**Town of Kittery Maine
 Planning Board Meeting
 August 27, 2020**

ITEM 1— 8 Wentworth Street, Rice Public Library – Preliminary Site Plan Review

**RE: Town of Kittery, Planning Board Services
Site Plan Review
Rice Public Library (8 Wentworth Street) Tax Map 4, Lot 88
CMA #591.132**

SHEET 1 OF 1

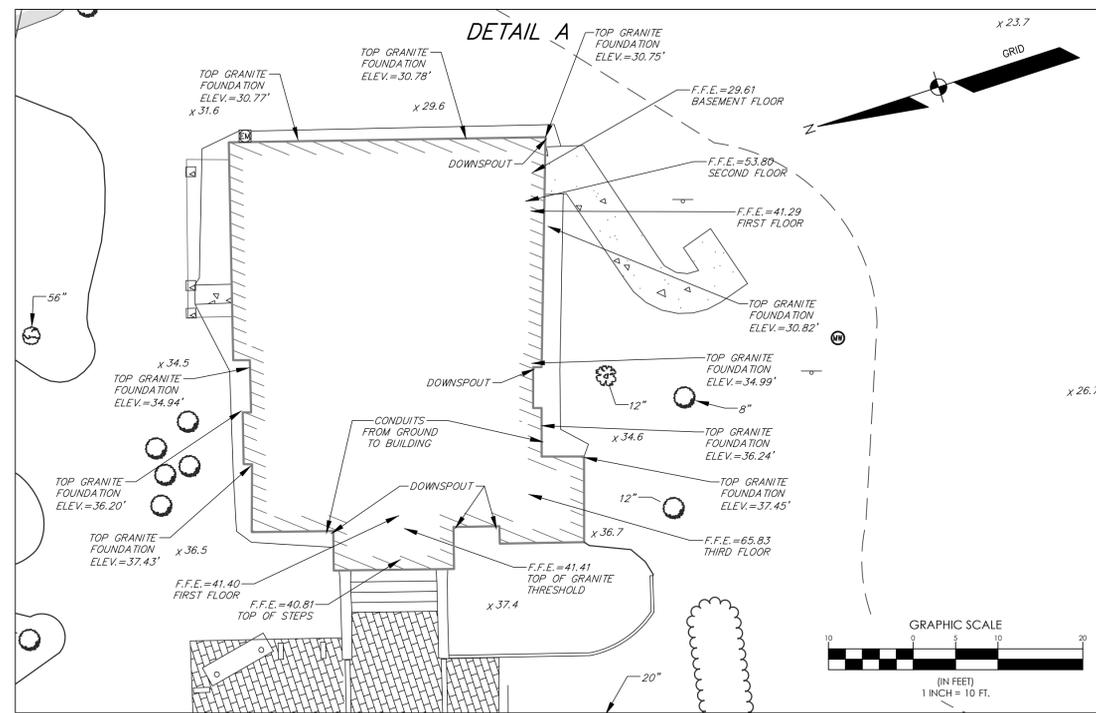
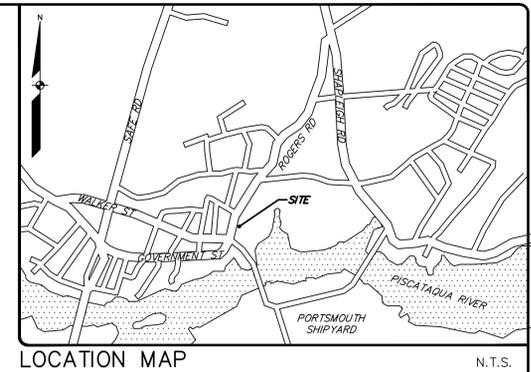
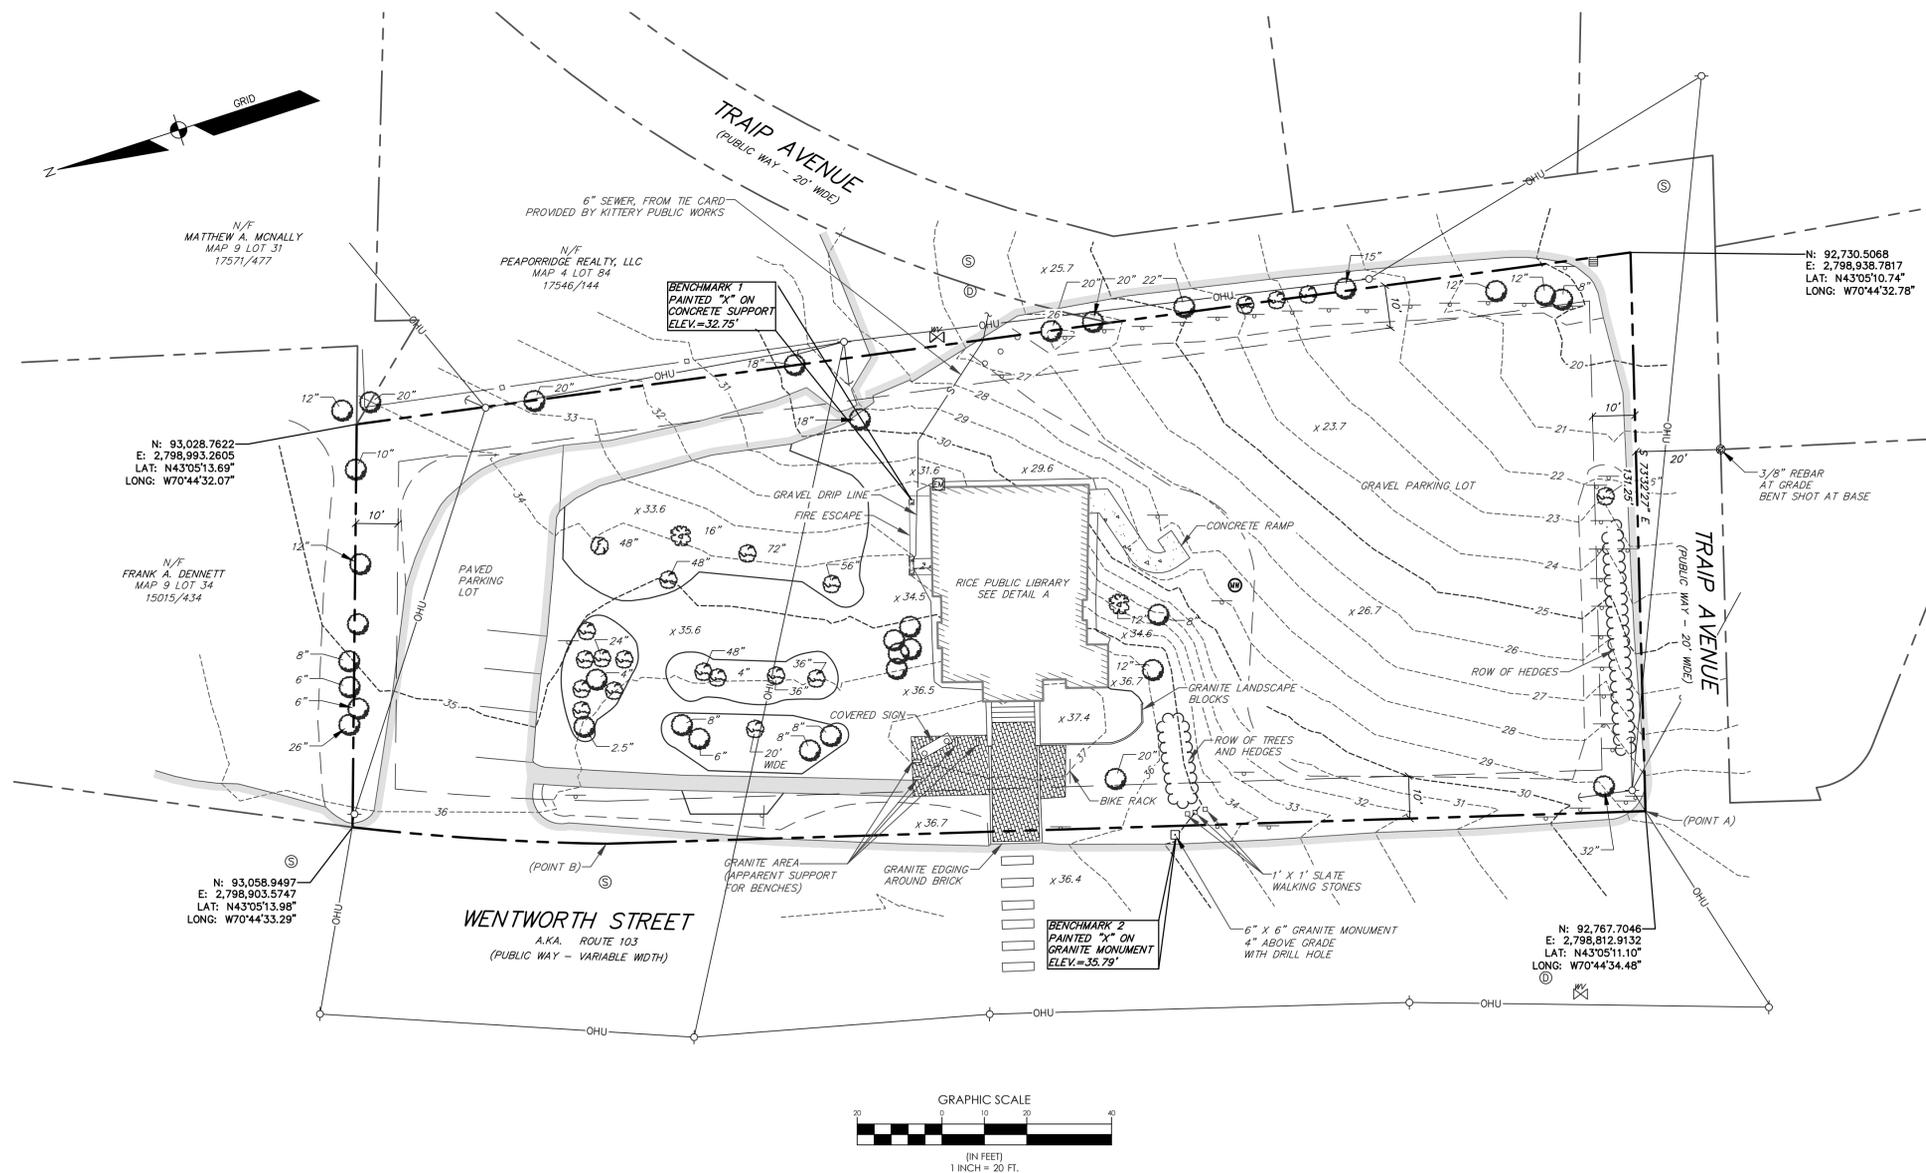
8. The "Surveyor's Statement" on Sheet 1 of 1 needs endorsement.
9. While an erosion control plan is provided by the Applicant there appears a construction sequencing plan has not been furnished. The Applicant should provide a construction sequencing plan to the Board for review and approval.

SLOPED GRANITE CURB (ALT #1)
NOT TO SCALE

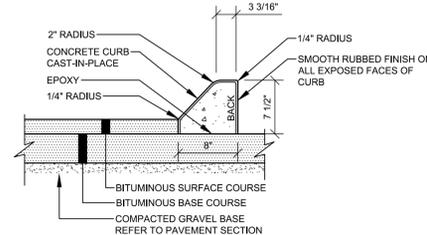
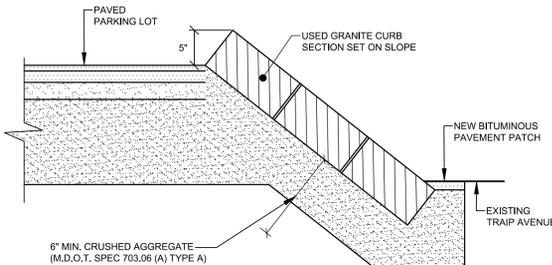
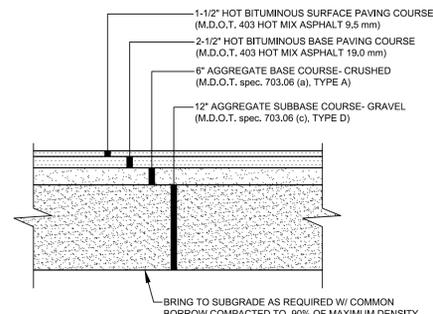
1. All proposed granite curbing shall be sloped in order to accommodate the fire trucks.
2. The 6" water lines coming off of Traip Avenue must be verified to be adequate to support the proposed sprinkler system. Applicant should contact the Fire Department to confirm adequacy.
3. Maintenance on the basement floor of the proposed expansion shall be in a location that permits immediate access for fire/rescue staff.
4. Determination letter from Maine Historical should be provided prior to commencement of work.
5. Revised elevations need to be provided prior to final approval
6. Prior to construction, the applicant needs to contact the Department of Public Works to review the construction sequencing plans so as to ensure the proposed utilities that intersect the corner of Traip Avenue and Wentworth Street are compatible.

- There were concerns from the Fire Chief as to fire vehicles being able to negotiate the back corner on Traip Ave if the boundary line as shown on the plans is used (currently that corner is paved and seems part of the road)

This detail has been revised. See Sheet 7 of 8.
